Project	Bondi Surf Bathers Life Saving Club
Report	NCC Assessment Report (DA Stage)
Reference	C19506-NCC-r2
Date	19 April 2021
Client	Lockhart-Krause Architects
Contact	Jesse Lockhart-Krause jesse@lockhartkrause.com.au

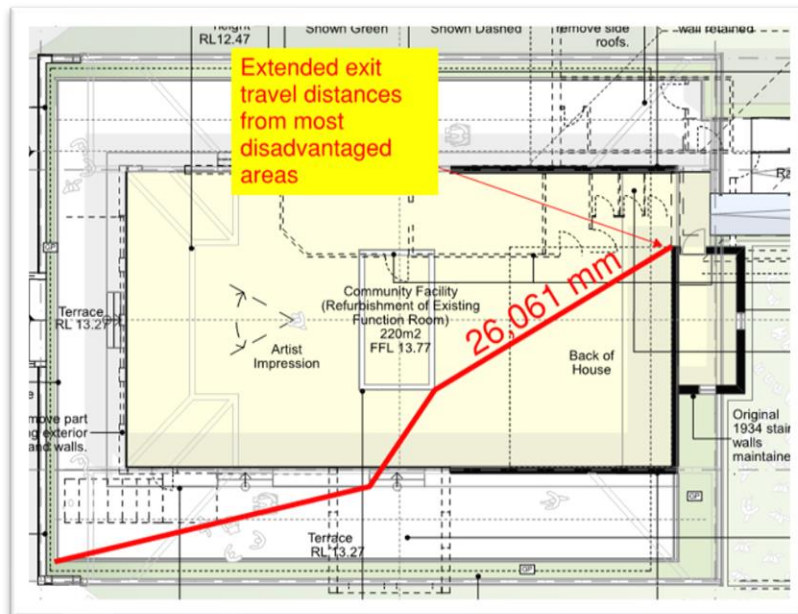
Credwell has undertaken an assessment of the most current DA stage architectural plans and considers that the following additional Performance Solution may be included in the FER.

Item	Possible Performance Solution	DtS Provision
1.	At the ground floor to either reduce or eliminate the protection required to windows and door openings that are within 6m of path of travel to open space from the heritage stair.	D1.7

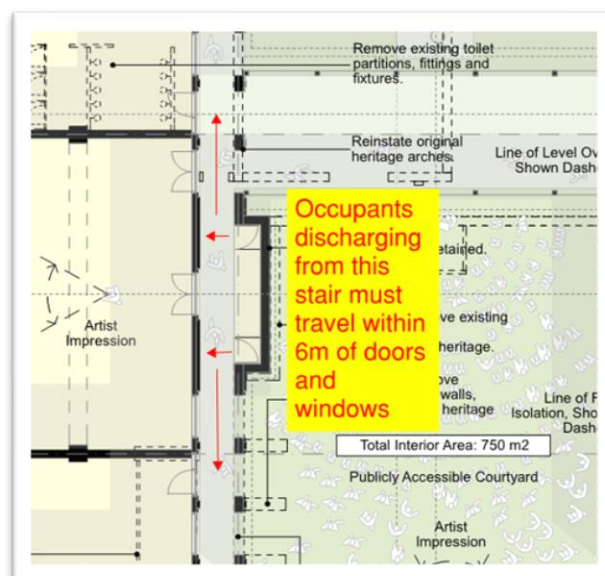
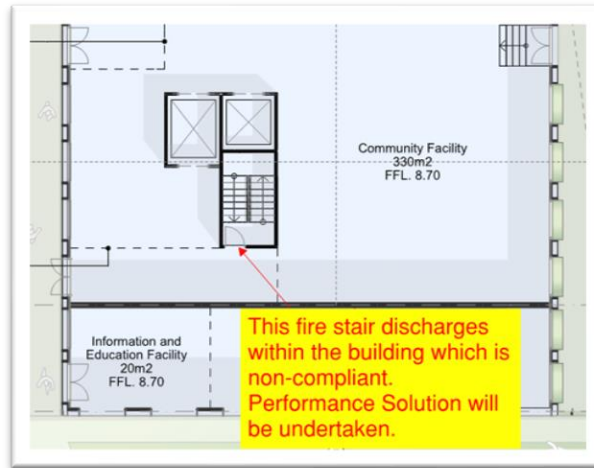
1. The heritage stairway discharges on the ground floor adjacent to the accessible courtyard. At the point of discharge occupants must pass within 6m of the swinging doors and windows serving the heritage hall. Therefore, under the requirements of this Clause the doorways and windows must be protected in accordance with Clause C3.4.

Regarding this item there is a possibility at a later of the development that a Performance Solution be undertaken to either reduce or eliminate the protection required the exposed openings.
